STAGE 4

project title	
KOKO + Hope & Anchor + Bayham Place Camden, London	
drawing title	scale / date
Proposed First Floor Plan	1:100 @ A1 13.04.17
drawing number	drawn / checked
AHA/KKG/GA/101	FR/PC DA
	revision
	D

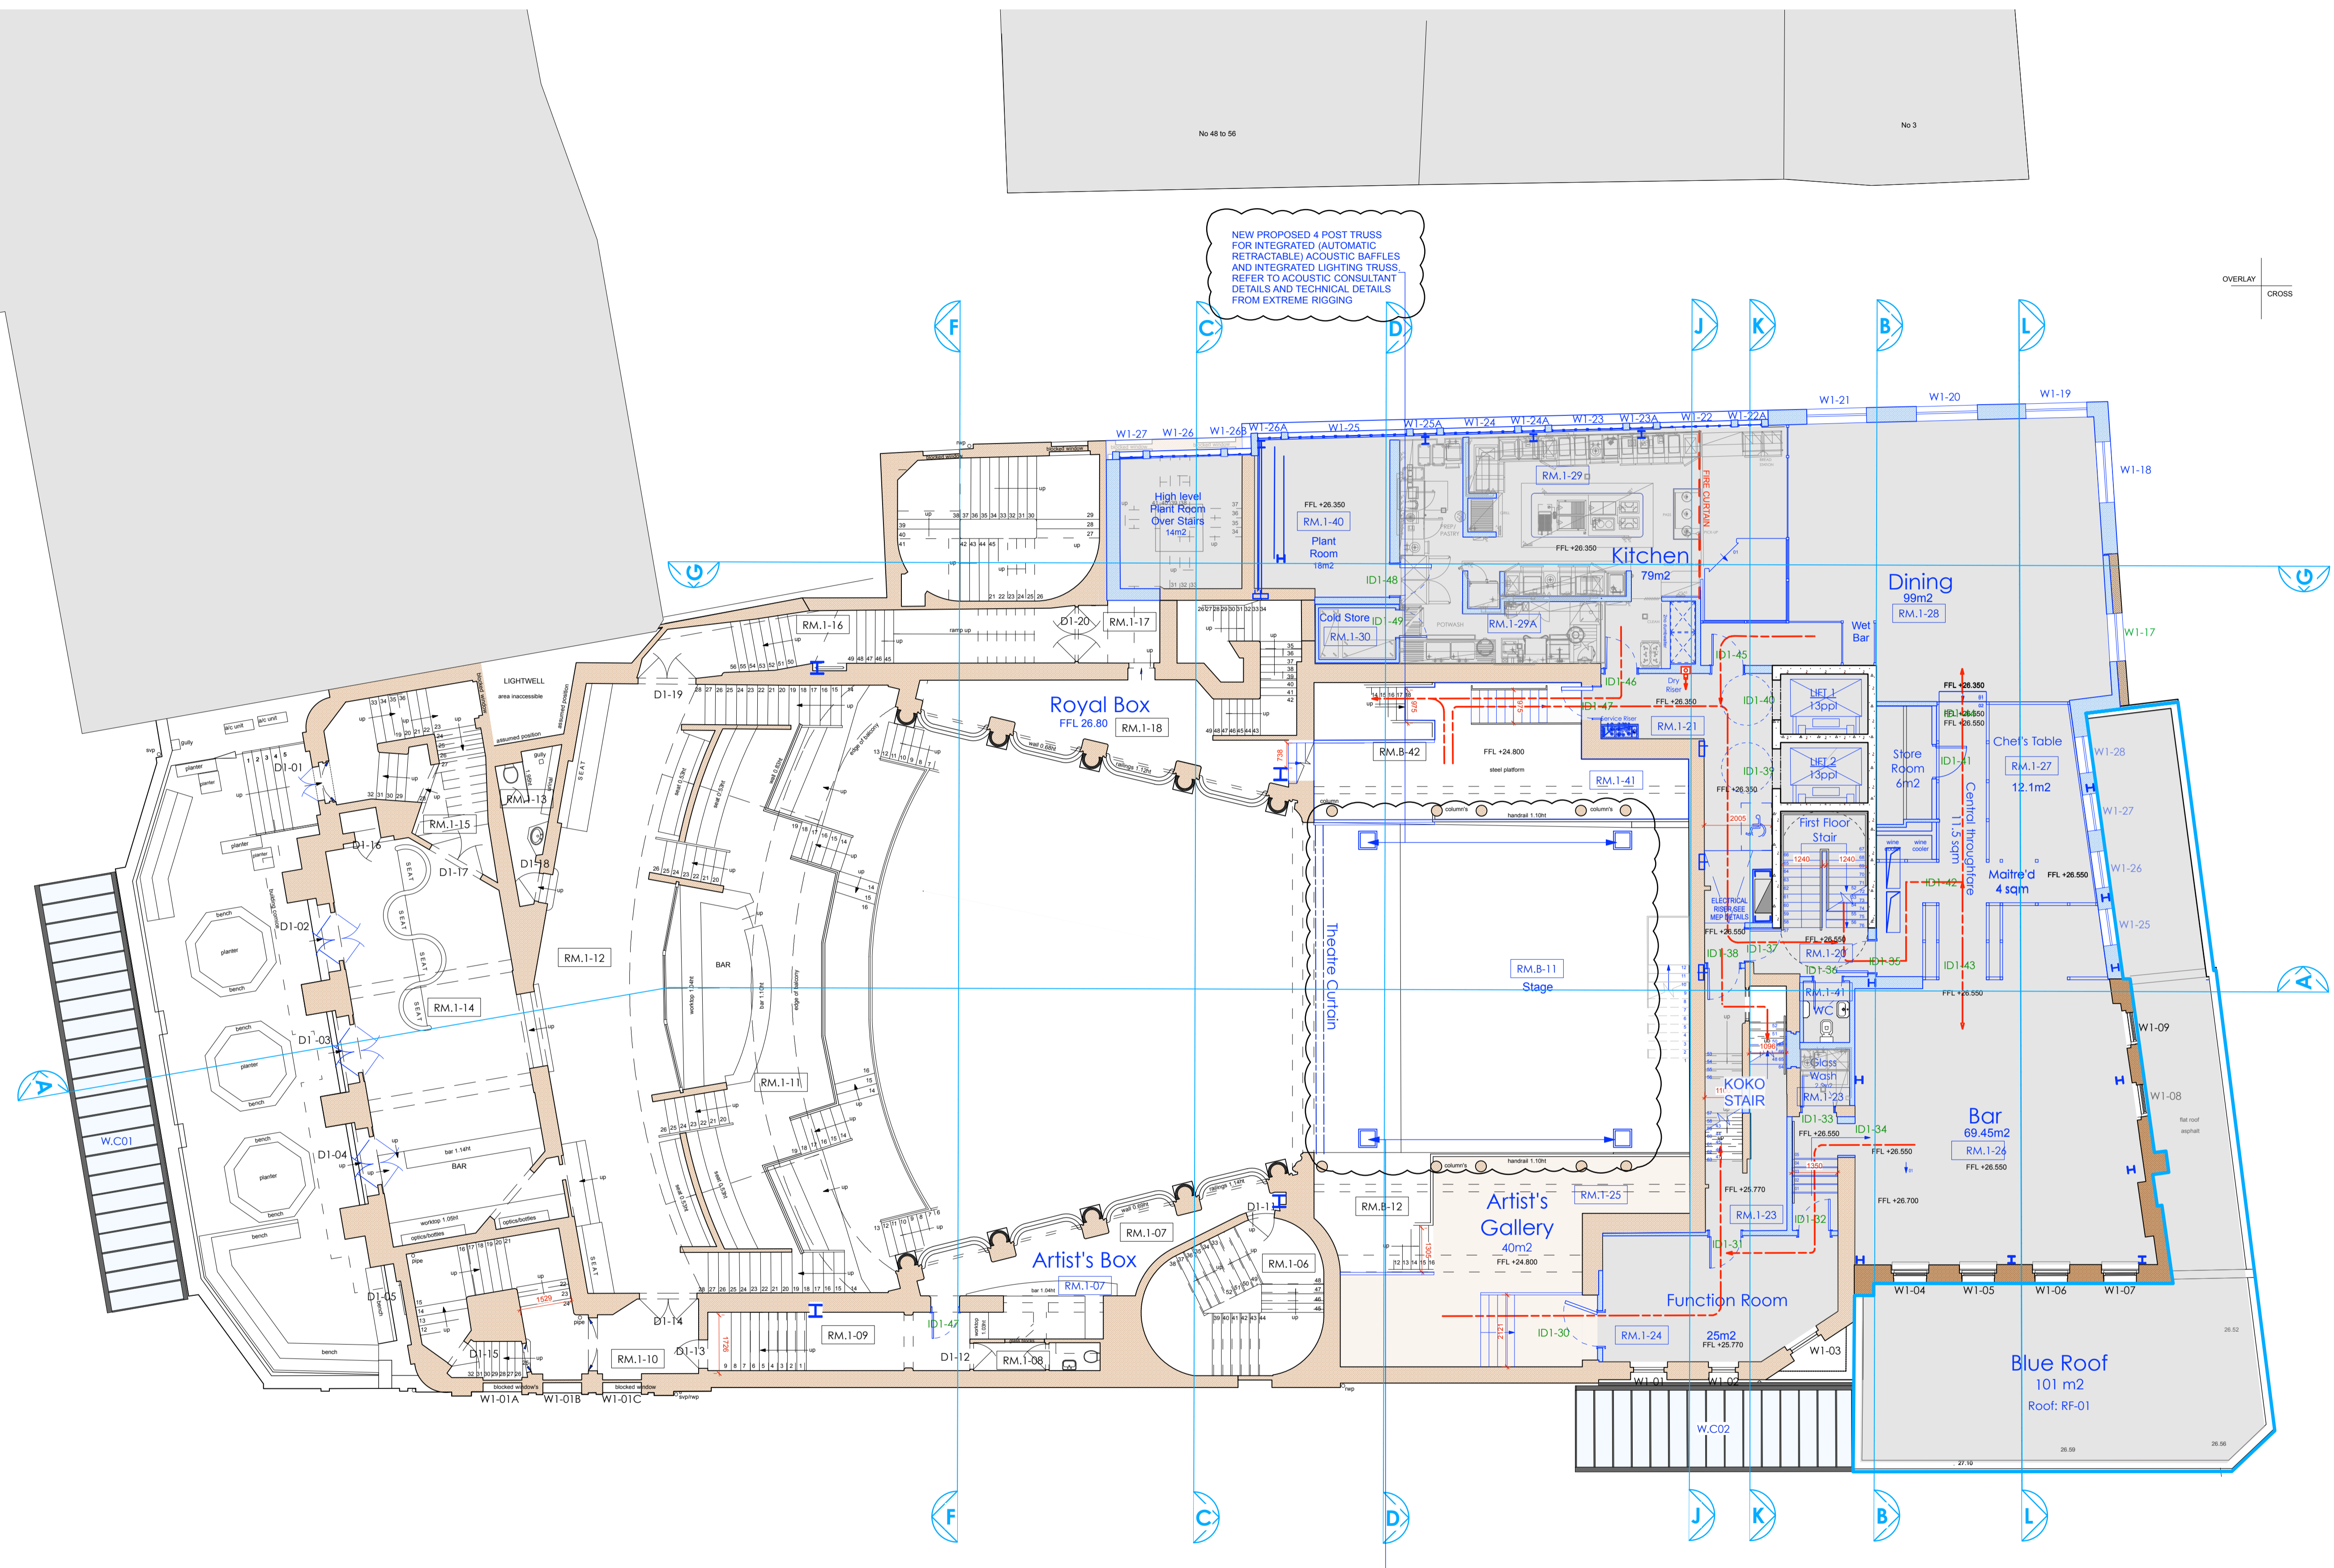
revision / date / amendments	First Issue
- / 26/01/18 /	- Window numbers updated in line with Window schedule.
A / 01/03/18 /	1. Tender Addendum [1], Indication of 4 post truss fixed at stage level for integrated automatic retractable acoustic baffles and integrated lighting rig.
B / 23/03/18 /	2. Tender Addendum [2], New AHU + Attenuator over stage to be hung to existing relocated secondary beams in Flytower.
C / 12/04/18 /	- Window and Door number updated Listed Building Application
D / 01/06/18 /	1. Indication of 4 post truss fixed at stage level for integrated automatic retractable acoustic baffles and integrated lighting rig.
	2. New AHU + Attenuator over stage to be hung to existing relocated secondary beams in Flytower.

NEW PROPOSED 4 POST TRUSS FOR INTEGRATED (AUTOMATIC RETRACTABLE) ACOUSTIC BAFFLES AND INTEGRATED LIGHTING TRUSS. REFER TO ACOUSTIC CONSULTANT DETAILS AND TECHNICAL DETAILS FROM EXTREME RIGGING

NEW PROPOSED 4 POST TRUSS FOR INTEGRATED (AUTOMATIC RETRACTABLE) ACOUSTIC BAFFLES AND INTEGRATED LIGHTING TRUSS. REFER TO ACOUSTIC CONSULTANT DETAILS AND TECHNICAL DETAILS FROM EXTREME RIGGING
